**NSLPP MEETING HELD ON 04/12/2024
SECTION 4.55 APPLICATION REPORT**

ADDRESS: 58 Cowdroy Avenue Cammeray

APPLICATION No: D60/22/2

PROPOSAL: To modify a consent for demolition of existing dwelling and ancillary structures and construction of a dwelling house and associated works including a swimming pool.

DRAWING NAME.
SECTION AA

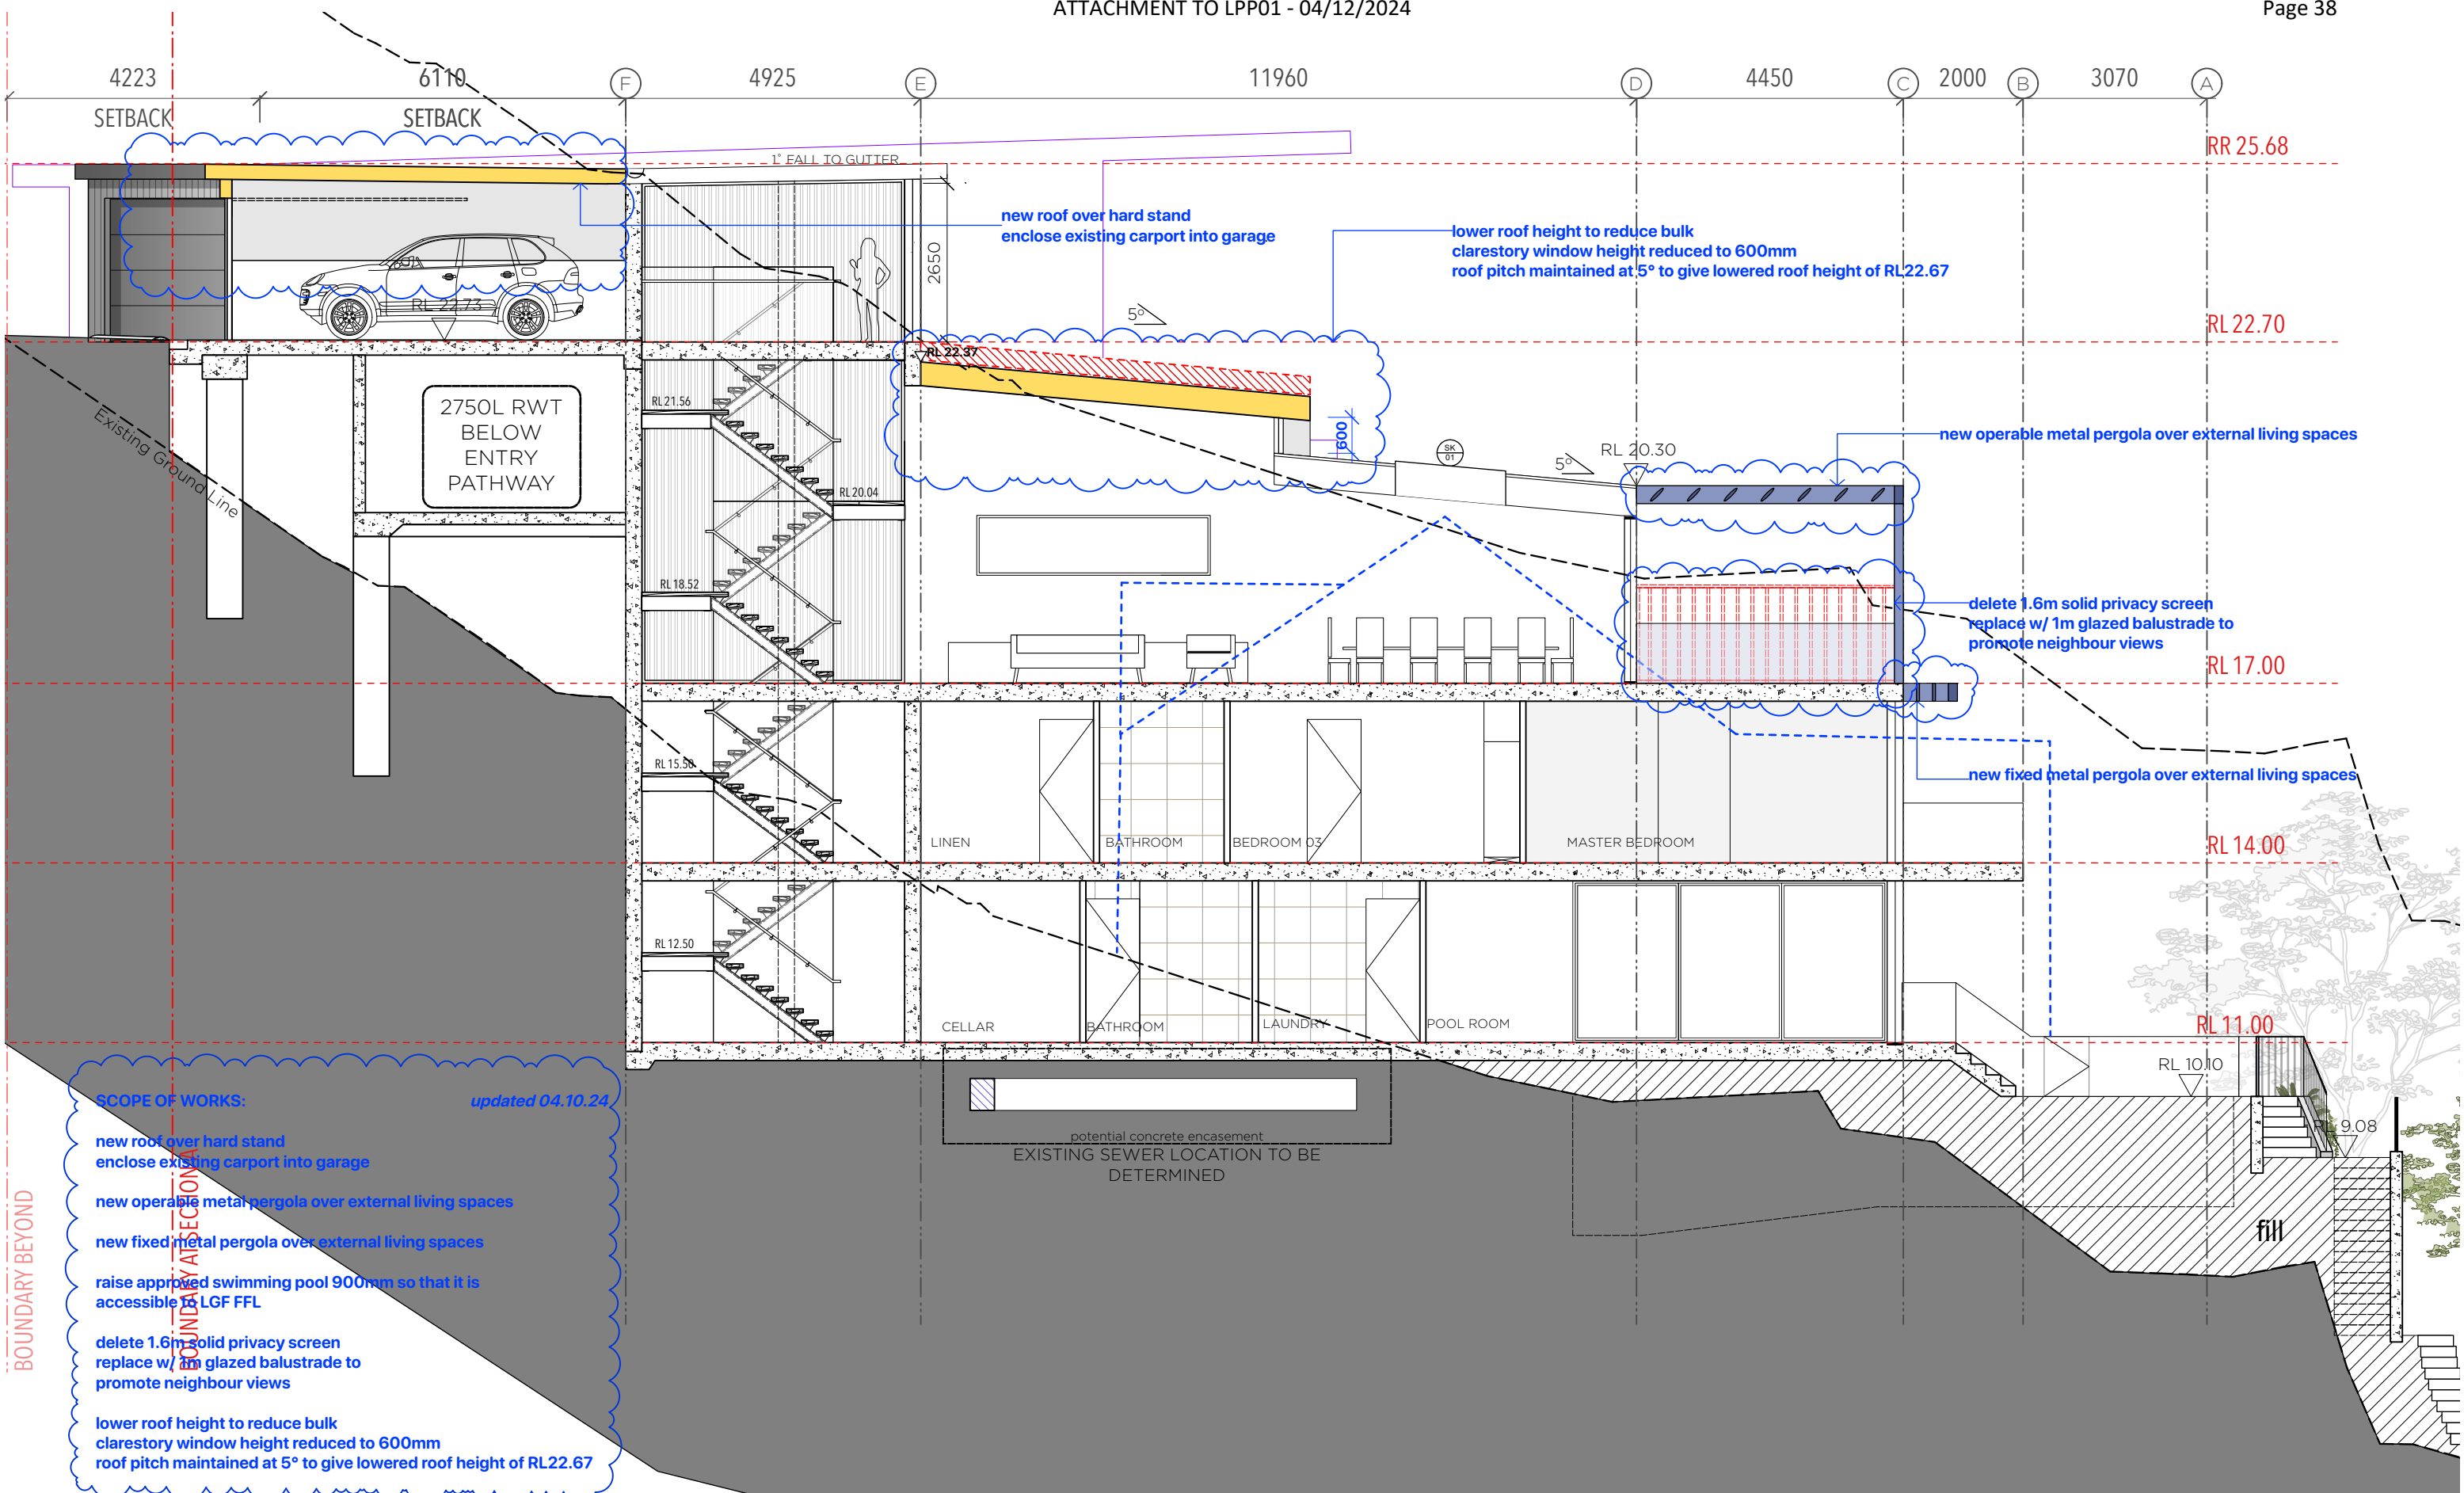
- The amended design is less compatible with the area and reduces foreshore amenity.
- There is no setback to the carport, proposed to be enclosed as a garage.
- Discrepancy in plans regarding a proposed awning's depth over the balcony on the Mid-level floor plan.

The revised building height is consistent with the Panel's rationale as outlined above, noting the lowering roof height by 600mm reduces the bulk of the building.

- l) *The awning proposed over the lower level deck shall be no deeper than 900mm measured outwards from the floor slab to which it will be affixed, as shown on drawing 4.55 107, Revision B, 24 10 2024.***

View Sharing Analysis Diagram
 taken from 56 Cowdroy Ave Cammeray

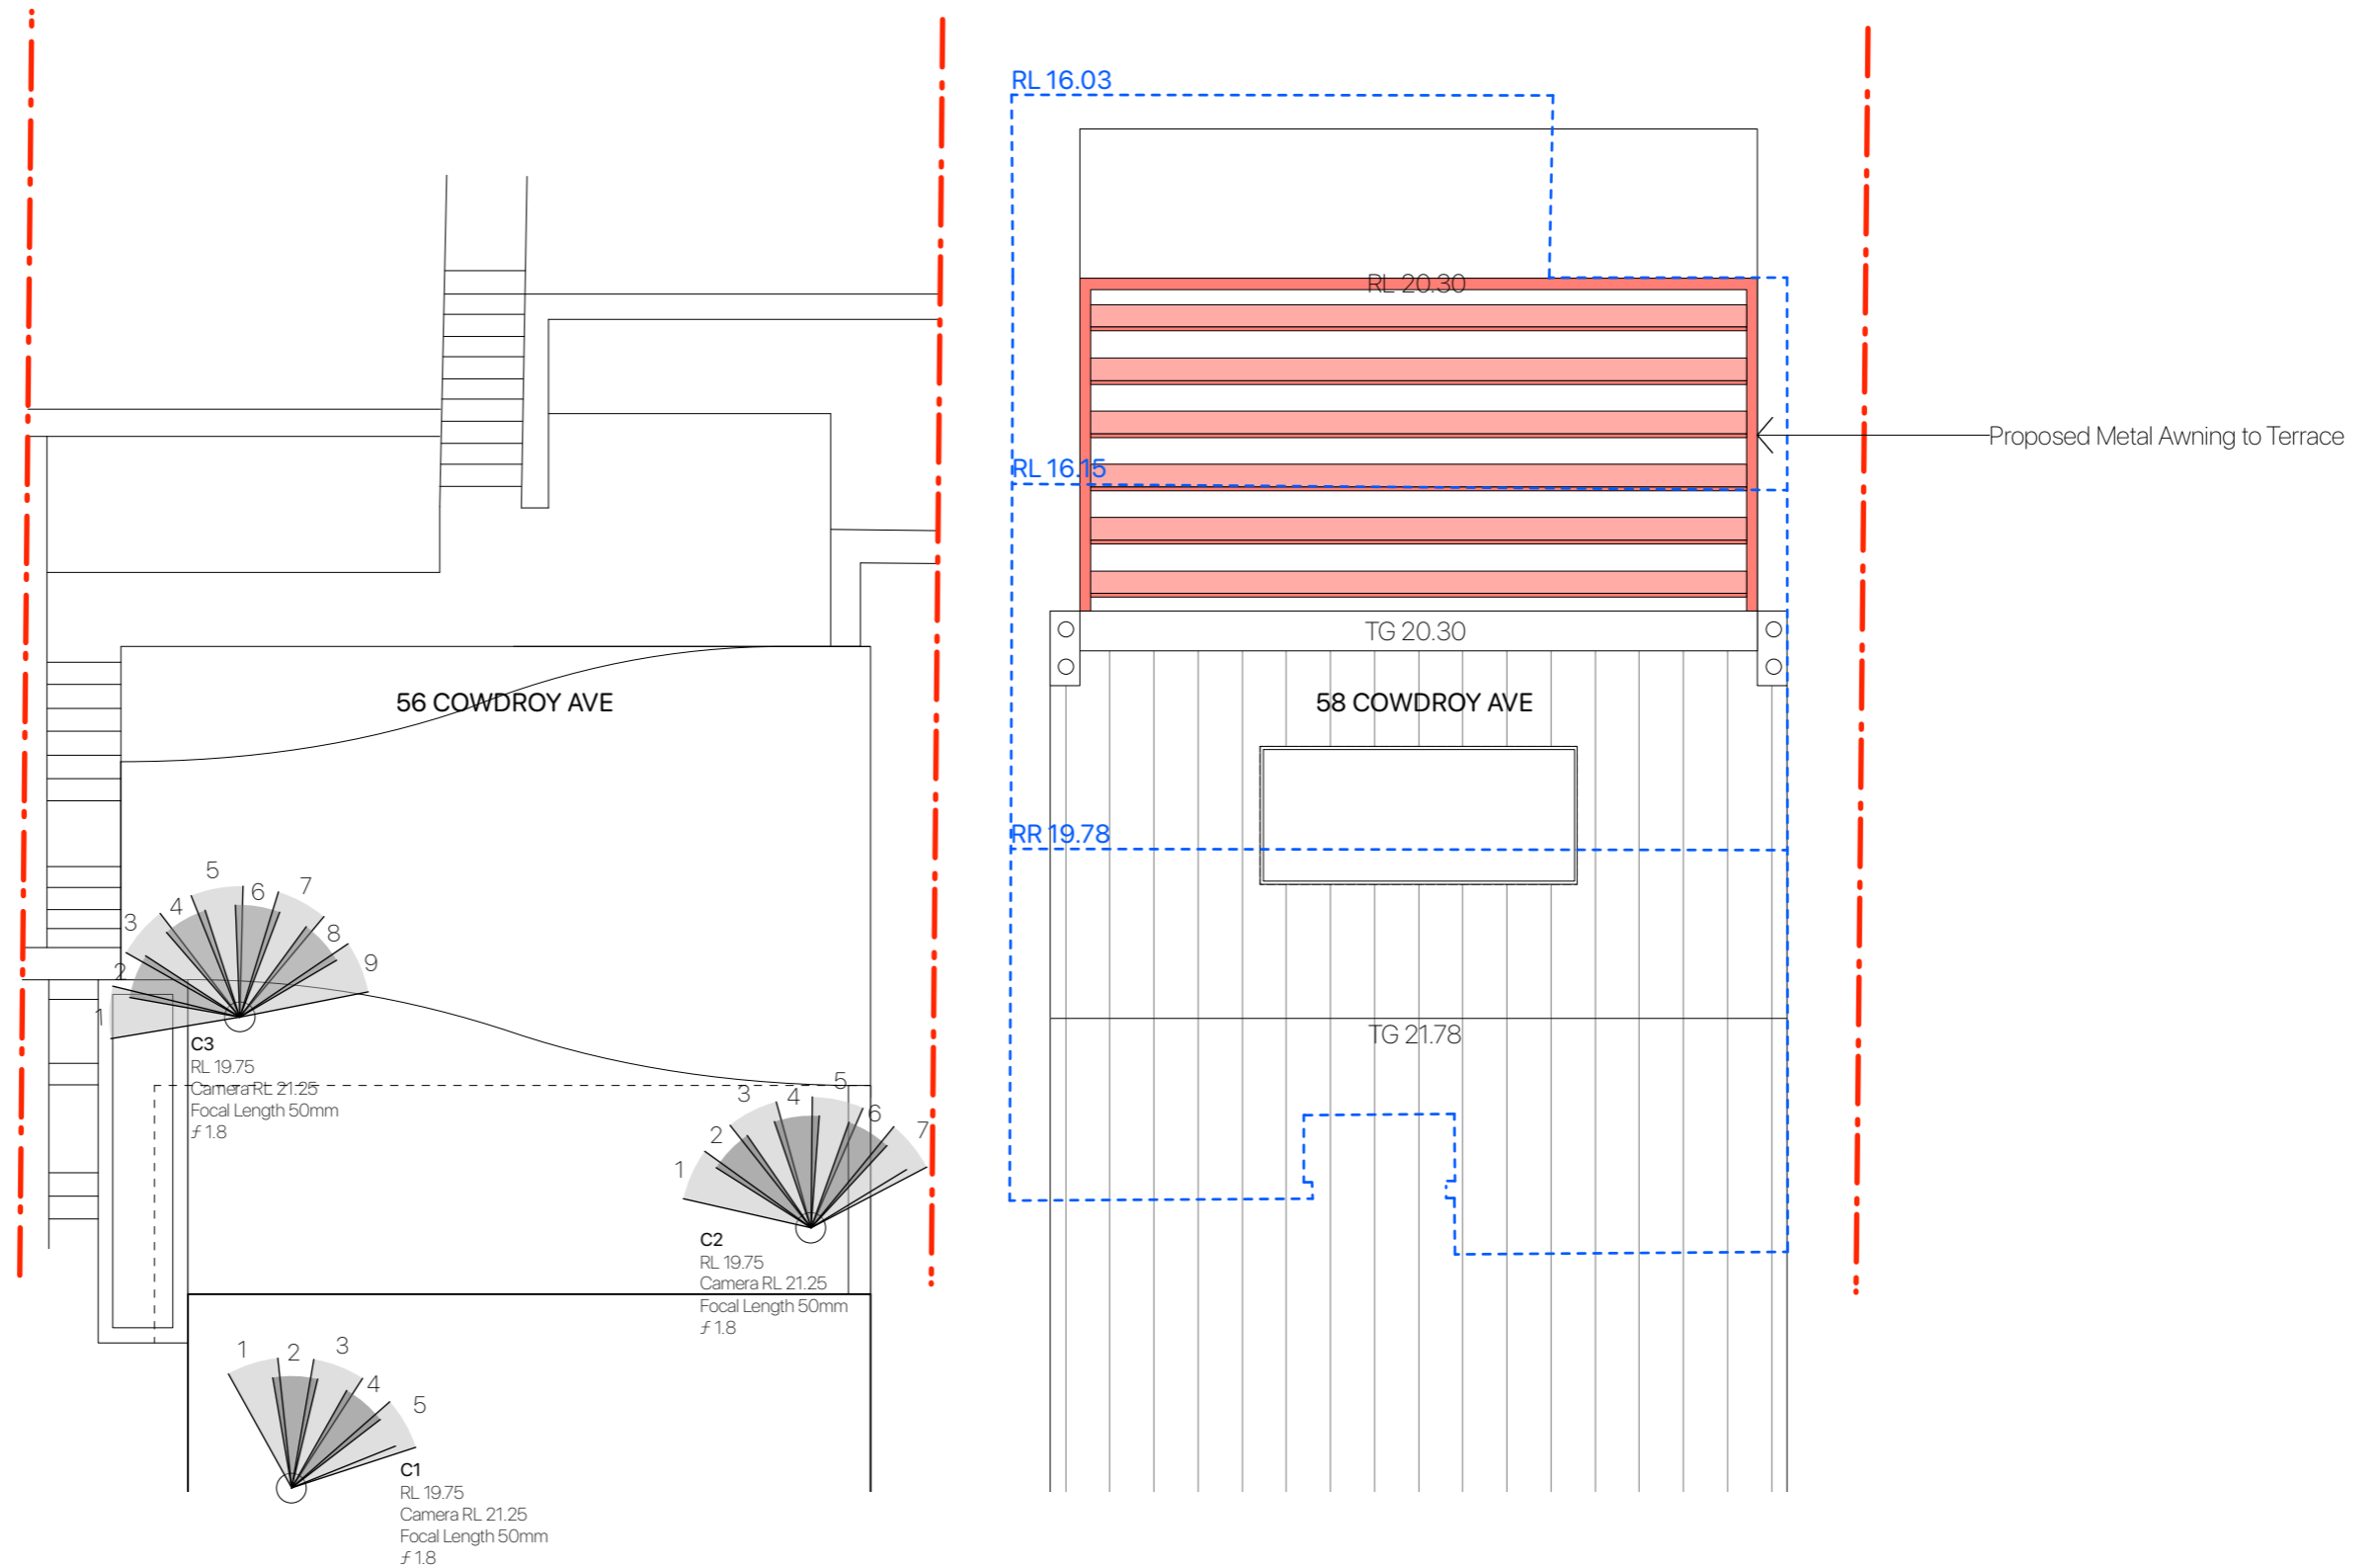
View impacts are further examined later, in relation to the DCP. This examination indicates the modifications do not alter the development's consistency with the objective to retain and share views.
